OFFICER'S REPORT FOR:

Independent Hearing Commissioners

Variation 1 Rezonings

Peter Wilson

Figure - 200 year Model Results

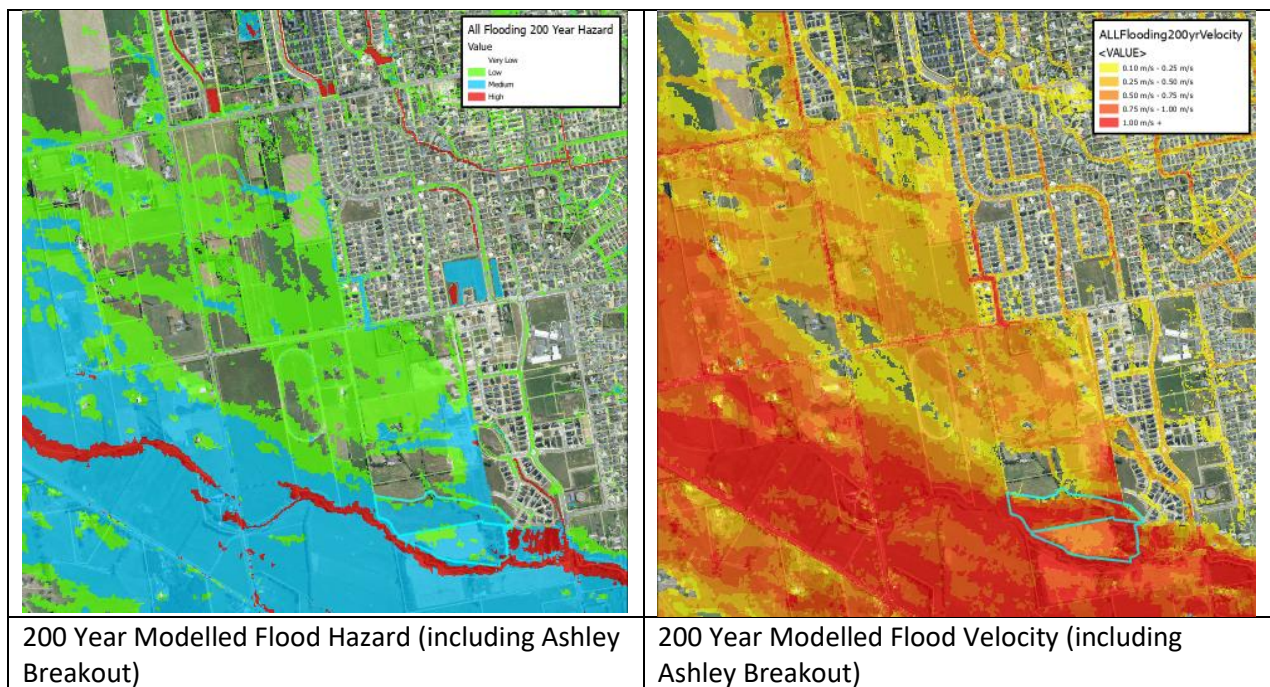
- *As discussed, I have reviewed the proposal to rezone the land at 117 and 113 Townsend Road (now 20 and 24 Angus Place) in respect to the underlying flood hazard from an Ashley River Breakout.*
- *These properties are both under the flowpath from an Ashley River breakout and are shown as having significant areas of Medium Flood Hazard in both the 200 year and 500 year flood events. Under an Ashley River breakout scenario both parcels of land would be subject to significant flood velocities exceeding 1.0 m/s. Refer to Figure for the model results.*

- *In my opinion it would be impractical to mitigate this flood hazard. Any attempts to raise the land or provide for a bund to the west would impact severely on neighbouring properties to the south and would represent an obstruction to the Ashley River Breakout pushing the primary breakout channel further south. Without better understanding the impacts of such works on these neighbouring properties and the larger flood channel it would be inappropriate in my opinion for the Council to support a residential rezoning request in this area.*
- *It is noted that Townsend Fields have previously undertaken works to mitigate a much smaller flood hazard to the north of these sites by constructing a temporary bund and diverting floodwater through*

Figure 6 Proposed ODP changes

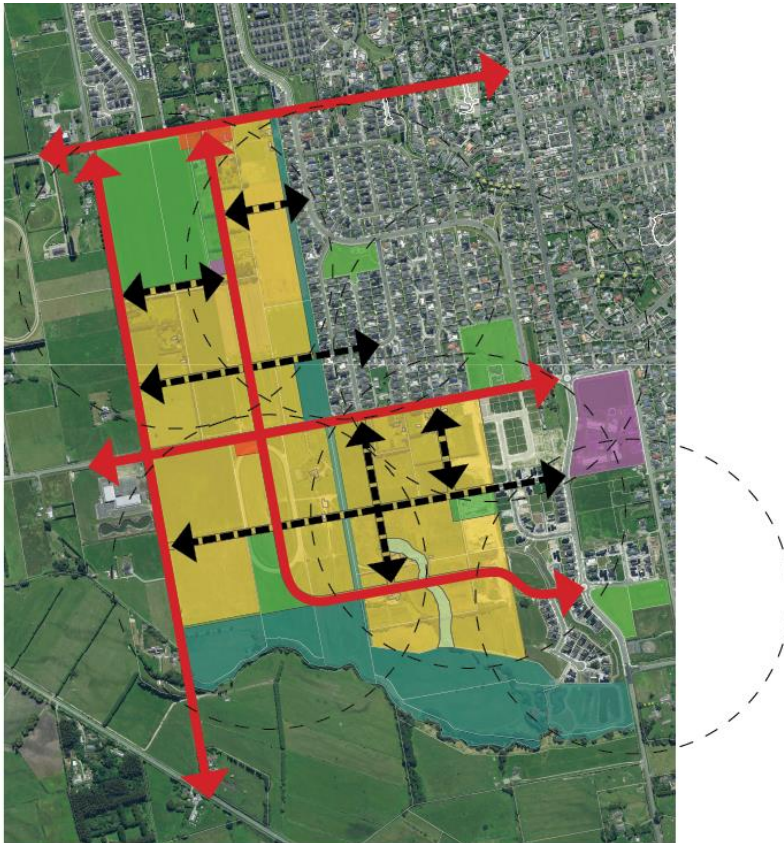
87. Mr Jolly’s changes are below that incorporate the above matters:

Figure 9 Proposed amendments to WR and SWR ODP

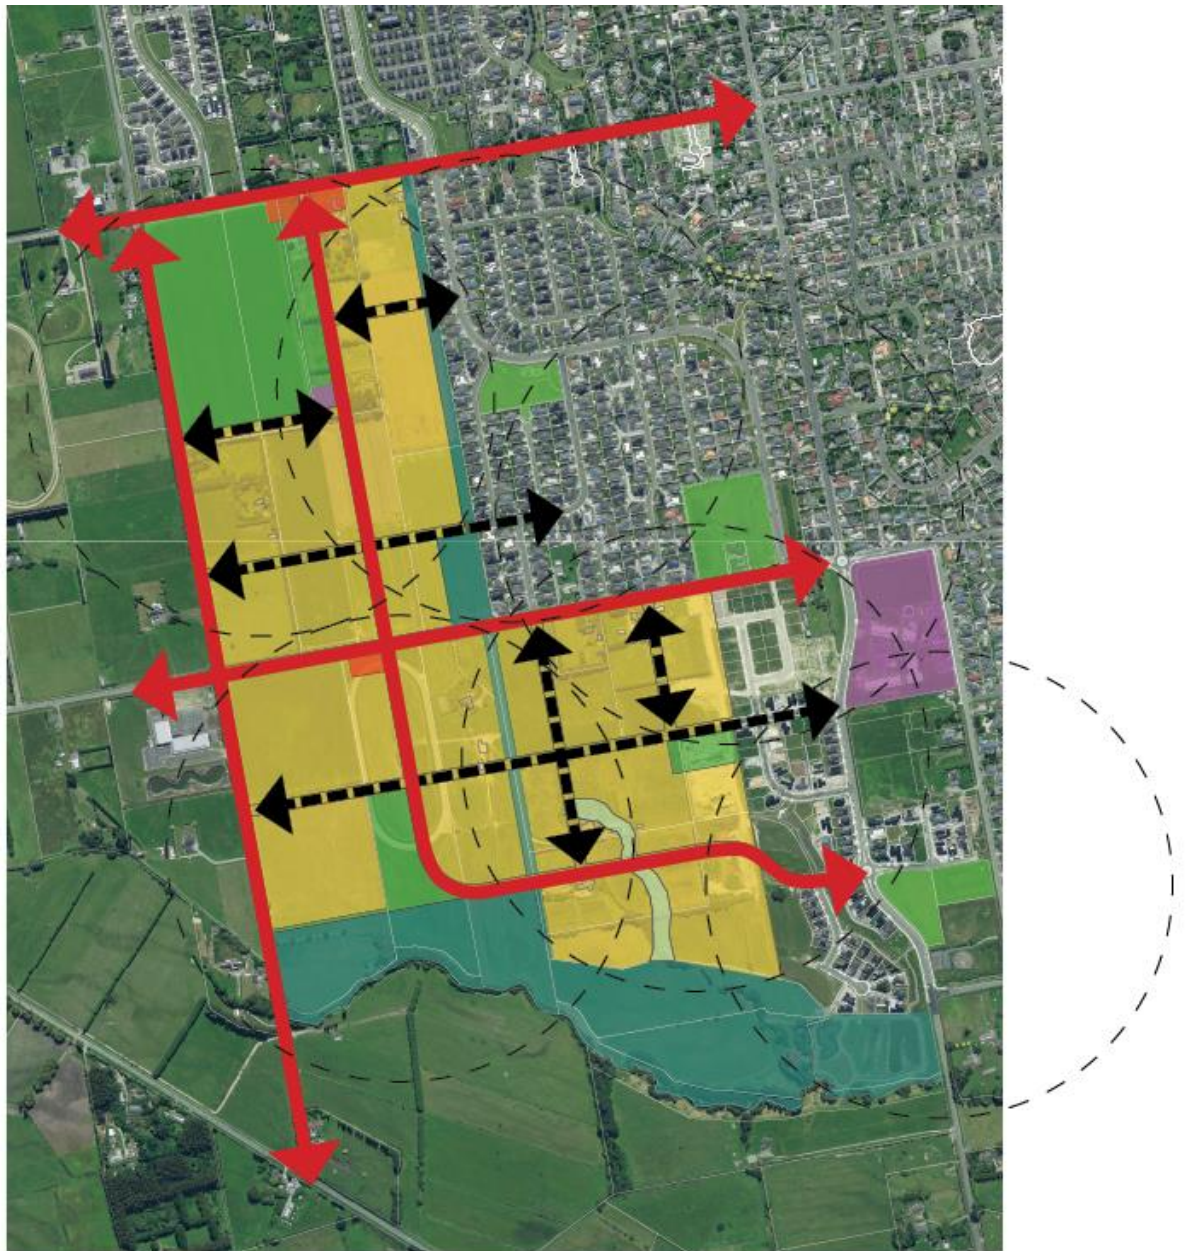
111. Mr Jolly has thus supplied amendments to the ODP that show these future options in respect of this land:

Figure 19 Additional Bellgrove land ('error parcel')

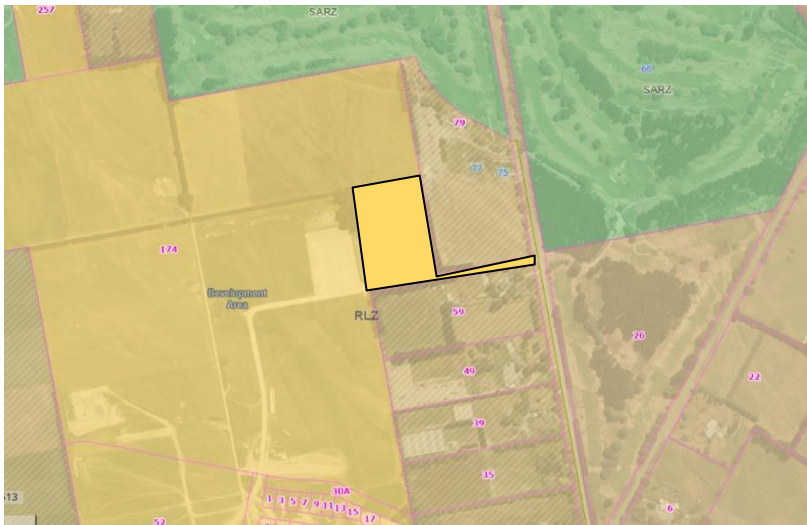
172. Bellgrove Rangiora Limited [V1 79.10] request updates and changes to the NER development area. These changes are as requested in their evidence in hearing stream 10A¹⁷, and include the addition of an additional area of Bellgrove Rangiora Ltd owned land that was left out of the Variation 1 maps.

Figure 8: Relationship between traffic generation and delays, derived from Mr Carr's evidence and models

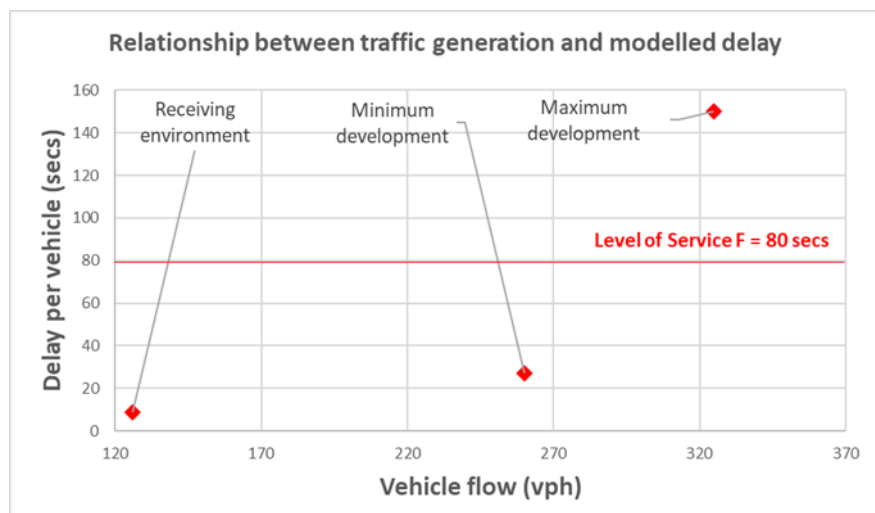
119 I have analysed Mr Carr's evidence and data to develop Figure 8. It shows the relationship between modelled demand (vehicles per hour) and delay, and the pattern between the outcomes of the receiving environment, the minimum and maximum development scenarios. Although this samples the outcome for a single movement at the intersection, the pattern would be the same for any other movement. It is typical in traffic engineering that each additional vehicle added will increase the overall delay at an escalating rate.

120 Figure 8 is developed as a reference, rather than a tool on which to base a detailed position. I note that the true value of the highest delay is not known, as it is reported by Mr Carr as ">150" seconds. For convenience, I shall treat it as 150 seconds.

Figure 9: Intercepting the point at which Level of Service F would be triggered.

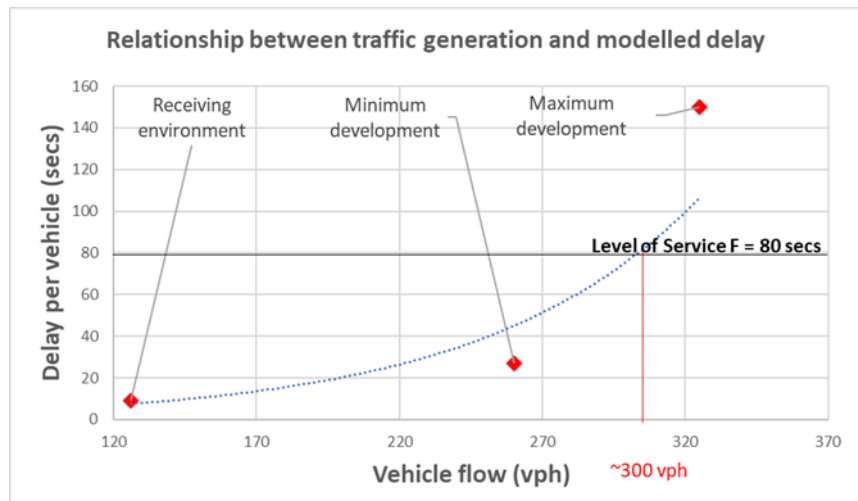
121 Figure 9 shows an application of the relationship shown in Figure 8, to intercept the point in flow at which LOS F would be reached. It is an aid to demonstrate that, in addition to the Beach Road approach which is shown to have 'failed' at the minimum development outcome, the

Smith Street and Williams Street approaches would like 'fail' prior to the 'maximum development' outcome.

122 Figure 9 is oversimplified, but does highlight the classic exponential relationship between demand and delay. It shows interception of the exponential trend (which notably isn't a perfect fit) at around 300 vehicles per hour. If the relationship between vehicle generation and development is approximately linear, then 300 vph represents about 60% of the maximum traffic outcome. This could be interpreted to mean that LOS F would be reached under a development scenario of approximately 780 dwellings.

123 I also note that Level of Service F is a 'worst case' target. Delays of 1 minute would be reached at around 715 dwellings, following the same approach shown in Figure 9.

124 I question the use of 'present day' design flows on which to base network design decisions. Detailed design outcomes should be able to accommodate growth. For context, if the demands at the intersection were to grow 2% per year, the 300 vehicles per hour shown in Figure 9 would be reached by year 8.

Figure 2 Alternative layout with central openspace reserve and additional stormwater aligned with water course and wetlands.

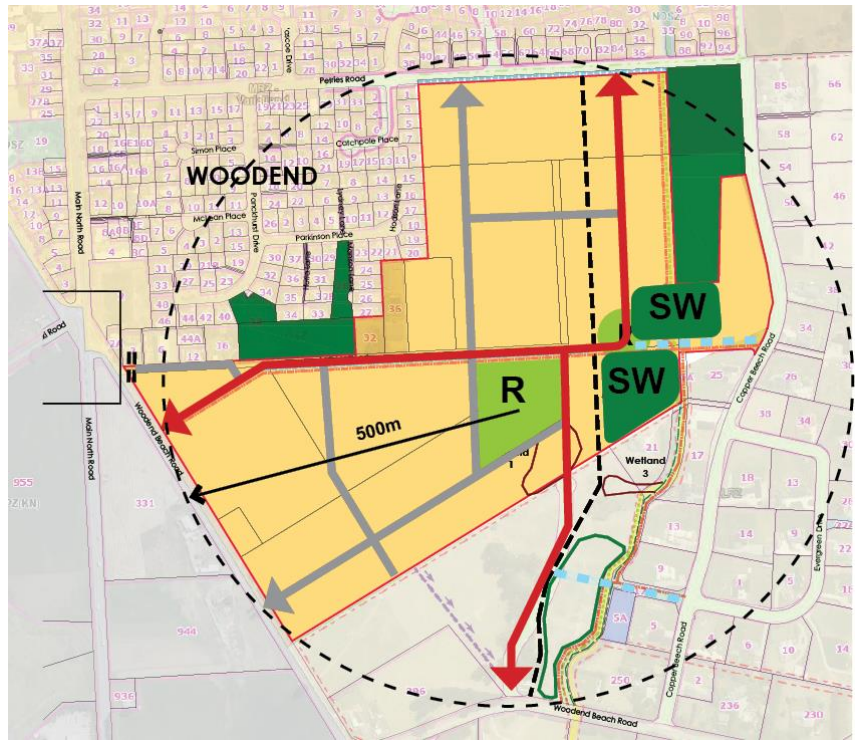
- The proposals provide very little in the way of public open space reserve. Medium density residential development will require higher demand on public open space and reserves therefore it is recommended to provide a centrally located large reserve with the site which will become a community focus and opportunity for passive recreation and play within the new neighbourhood. The alternative layout (figure 2) identifies a potential location for the reserve that will service new residential development within the ODP site. Its central location and size (approximately 1.5ha) allows it to provide access for the whole ODP site as it is within a 500m / 10minute walking distance from the majority of future homes. An alternative would be two smaller 0.75ha reserves, one located centrally in the northern area and one in the southern.

Figure 4 Potential alternative layout

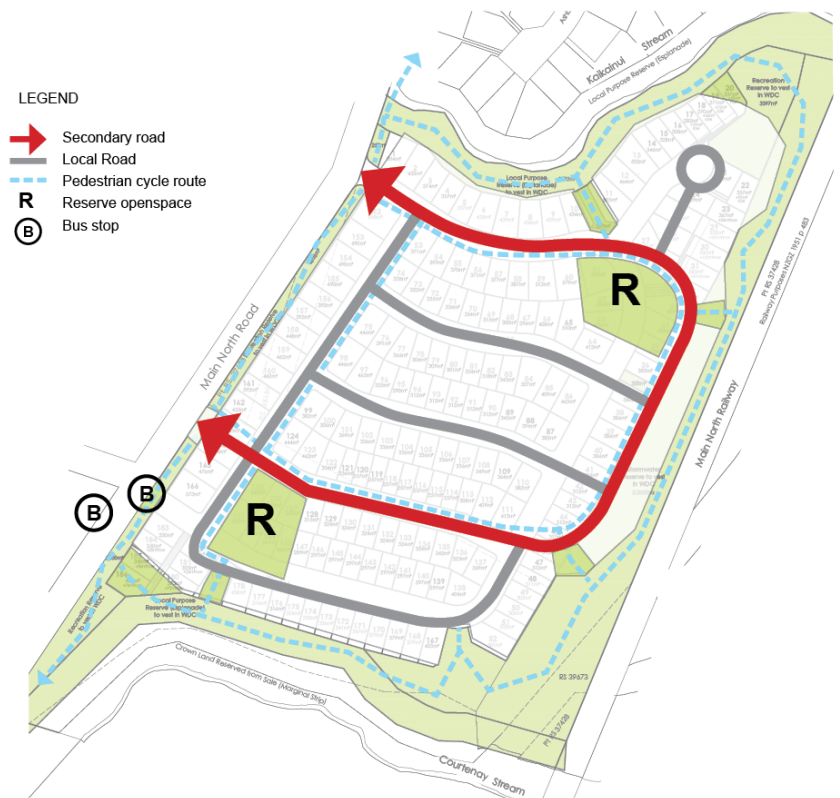
- The proposal does not identify any cycleways or key pedestrian routes which would provide benefit including connectivity within the site and with adjacent destinations such as Kaiapoi township. Figure 2 below shows a potential solution for the movement structure for the site and connectivity with its surrounding context.
- The two streams are key features adjacent to the site but have not been integrated into the proposal. There is opportunity for the neighbourhood to engage with these features through a series of interconnected walking and cycling routes that provide a unique feature of the development.

- The proposal provides a local reserve located in the protrusion of land to the north of the site between Kaikainui Stream and the main rail line. This is a poor location for open space as it is on the periphery of the site, it is hard to get to and is located through a cul-de-sac. The location of reserve openspace should be reconsidered in the proposal. Figure 2 illustrates an alternative where two openspace reserves are located centrally within the residential development. These locations will provide common openspace and potential to be a community gathering space and focus for the neighbourhood. They also have the potential to connect back through to the walking and cycling routes as previously identified overall creating a network of openspace and recreational opportunities for the site.

Figure 3 Proposed Street Hierarchy

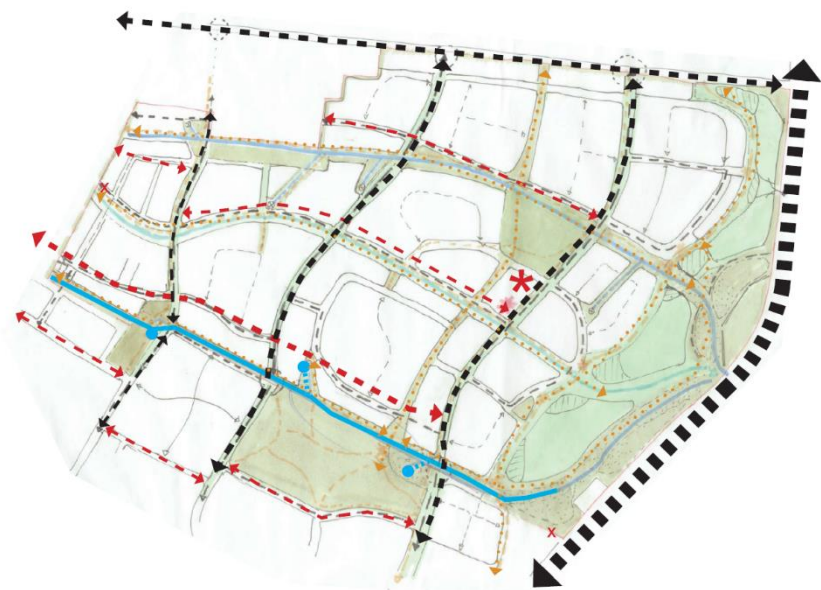
- The overall street hierarchy proposed with primary connectors supported by secondary streets at regular intervals sets up a logical and effective grid for development which will promote good legibility and wayfinding internally within the ODP. It is noted that from the 'sketch' plans provided (figures 1&2) that due to lack of a

legend to the plans and clear description the extents of the street network not completely clear. It is assumed that the black dashed lines are primary routes, the red dashed lines are secondary streets and the dotted yellow/brown lines are pedestrian and cycle routes. The diagram also illustrates where local streets and lanes will be located within each block in thick black solid and dashed lines (figure 3).

Figure 7 Sketch plan of potential ODP

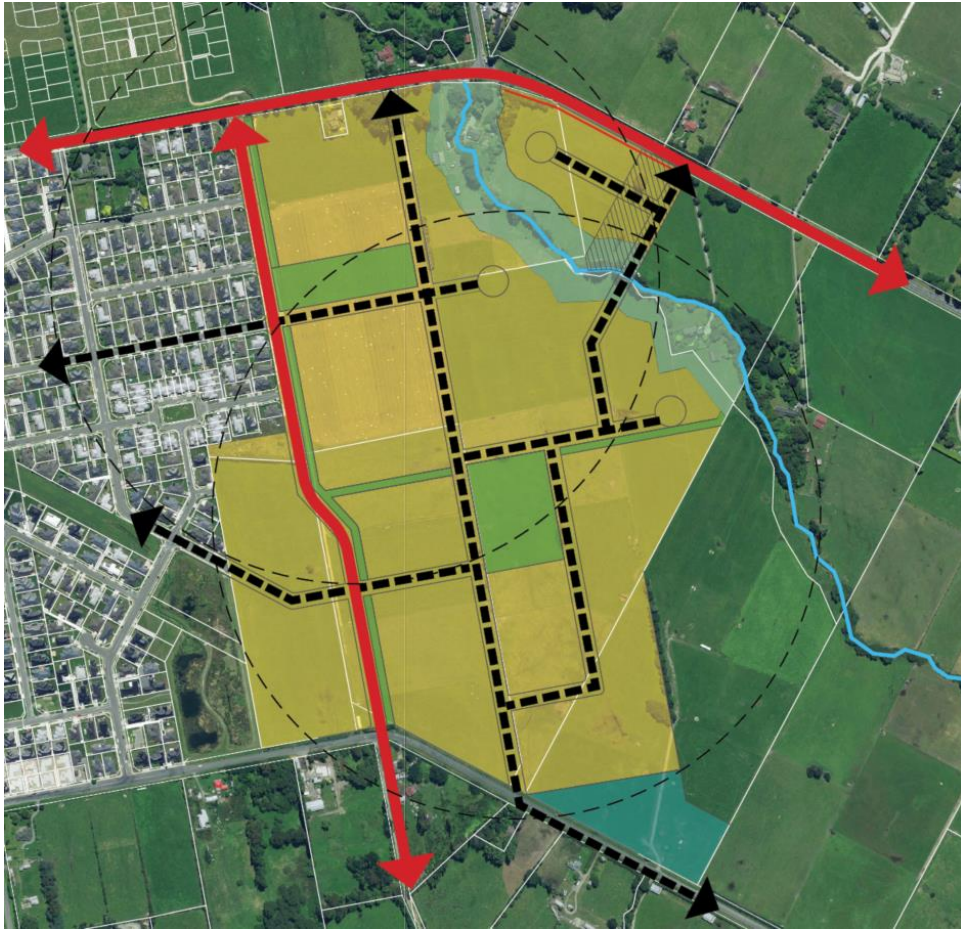
Jasmax has prepared a sketch plan (figure 2) to assist the preparation of potential amendments to the ODP and councils recommendations for this area that explores these two options.

Figure 10 Proposed ODP

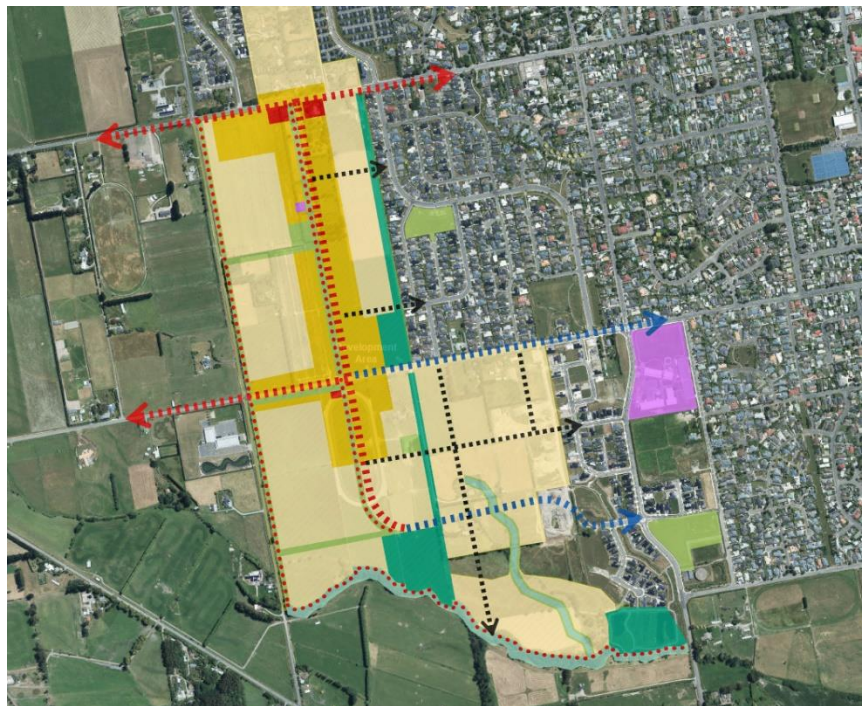
- The proposed primary road structure (in red) provides a logical north-south spine running the length of the area. It provides connection between the existing key east-west movement routes of Oxford Road and Johns Road. It is noted that Lehmans Road is also an important North South connector and interface with the rural zone on the edge of this area.
- The secondary movement (black dashed lines) connect the central primary route eastwards towards established neighbourhoods in western Rangiora. However these secondary connections do not connect west to Lehmans Road which would allow future residential development west of the central spine and good integration into the movement network. It is therefore recommended that the secondary movement streets extent to Lehmans Road as shown in Figure 2 below.

Figure 11 Recommended amendments to ODP

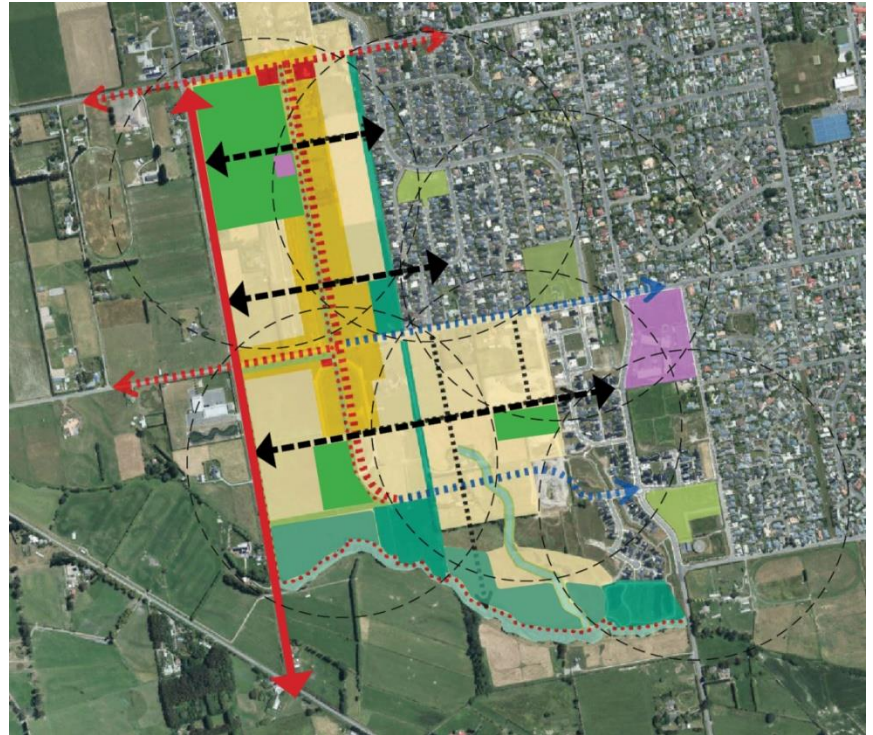
- Green space provision in the ODP is relatively limited and sparsely distributed through the area. The provision of open spaces is considered minimal both in terms of quantity and size. It is recommended that more substantial open space provision is provided within the ODP. Figure 2 below illustrates potential improvements to the ODP in terms of allocation of openspace, size and distribution. Note the dashed circles in the diagram represent

- 1) A large recreational space in the northern extent of the ODP between Oxford Road and the first east-west secondary road to replace the proposed pocket park adjacent to the spine road. It is also recommended that the community facility (purple square) is better integrated with the open space rather than separated by residential development.
- 2) A larger openspace in the southwest quadrant to replace the pocket park in this location, allowing greater coverage and access for future residential development.
- 3) An additional openspace on the important east west secondary street connection between Te Matauru Primary School and Lehmans Road.

Figure 1 Additional North Brook crossing and improved connectivity with wider SER ODP

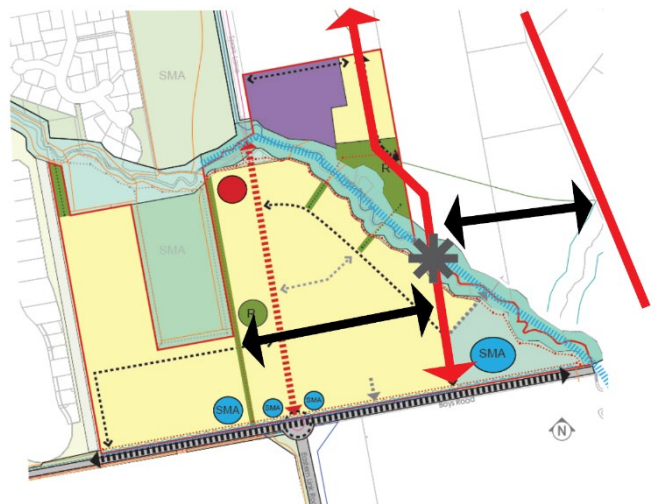
- However the secondary collector which is identified in the SER ODP also crossing the North Brook is absent in the proposal (shown as the red arrow in figure 1 below). Limiting the connectivity over the North Brook will potentially reduce the overall integration of future residential neighbourhoods. The location of the secondary collector in the SER ODP is in a logical location providing both east-west and north-south connectivity over the North Brook. Benefits of this secondary crossing include vehicular access alongside walking and cycling connectivity.
